Cement Asbestos Products Company

Subject: Change in PERMAFLEX® Gasket

14" & 16" CLASS 150 PERMAFLEX
GASKET REVISION

DWG. NO. A-36

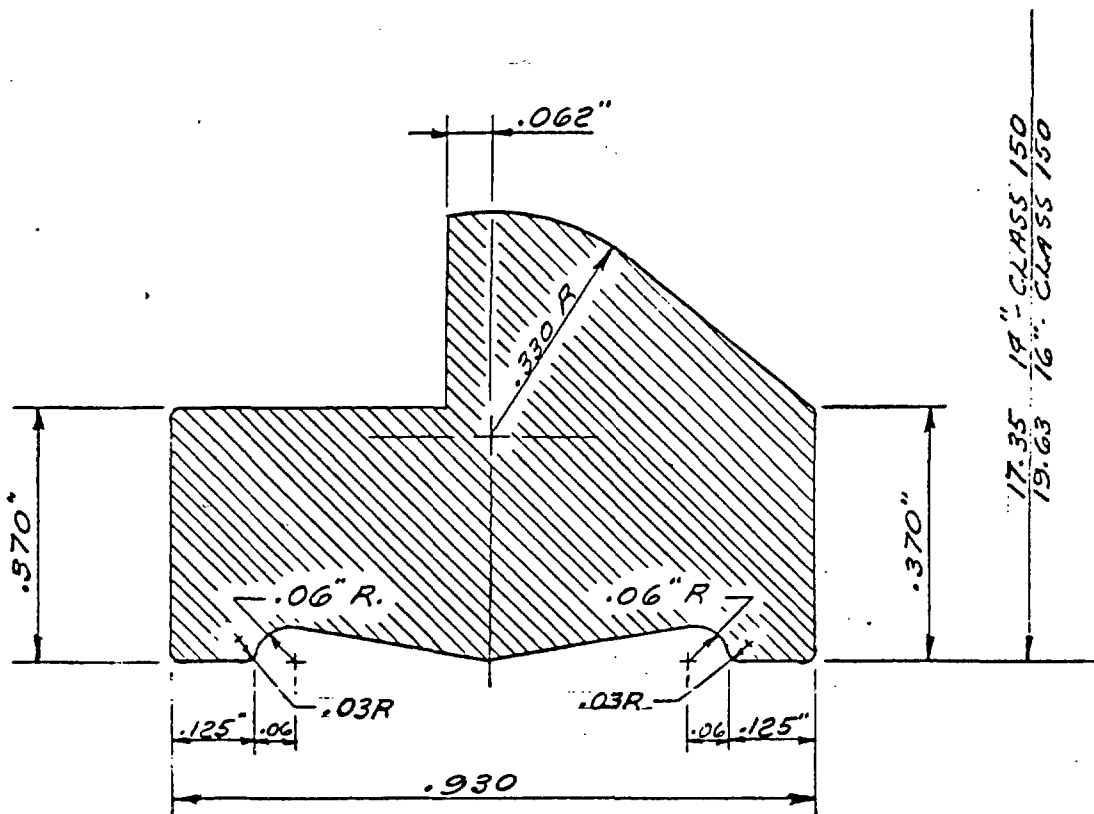
The 14" and 16" PERMAFLEX® gasket will be modified per the attached drawing. This gasket has been extensively tested in our laboratory and plant, and it is felt that this design makes a good gasket an even better one. The amount of pressure needed to assemble is no more than the old gasket, and this gasket has even greater stability in the gasket groove. After field experience with 14" and 16", we may wish to modify the other diameter.
